**RE: WCC Chatswood to St Leonards Bicycle Route via Pacific Hwy Draft Detailed Design plans**

The Artarmon Progress Association (APA) welcomes the opportunity to provide comments on the Willoughby City Council (WCC) Chatswood to St Leonards Bicycle Route via Pacific Hwy Draft Detail Design Plan.

**Figure 1 – Relocate Bus Stop 10 closer to Greenwich Rd.**

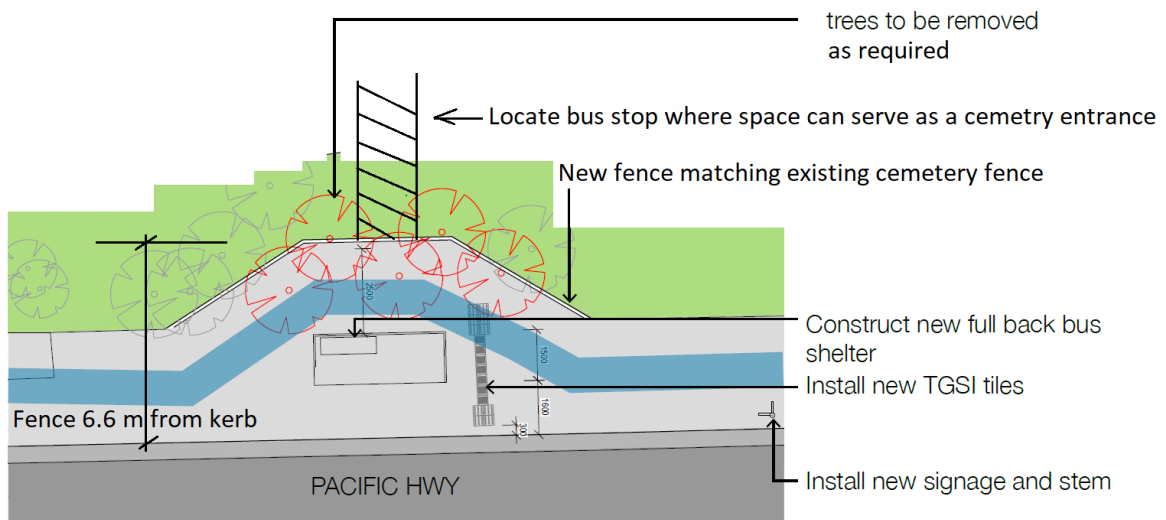
- Bus Stop 10 is 85 metres from the pedestrian crossing to Greenwich Rd with which it is intended to connect. Relocate the bus stop 60 metres closer to the crossing and align with a new pedestrian entrance to the cemetery. The aim here is for the community to use a small section of cemetery land as both a shared path and cemetery entrance. The Council would fund the works, with the cemetery trust only required to approve this dual use of its land.
- See Figures 1 to 3 below:

**Figure 2 – Detail of Bus Stop 10 relocated closer to Greenwich Rd.**

**Figure 3 – Reserve Rd to Herbert St - Use the row of trees to separate pedestrian and cycle movements.**

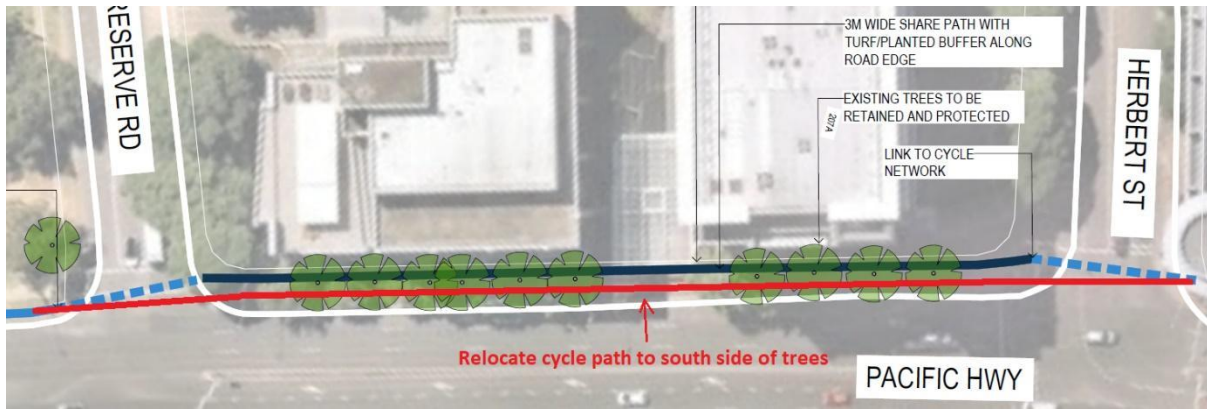
- The footpath is over 6 metres wide with a row of trees in the middle. The building (north) side of the tree should be for pedestrians, and the kerb (south) side for cyclists.
- See Figure 3 below:
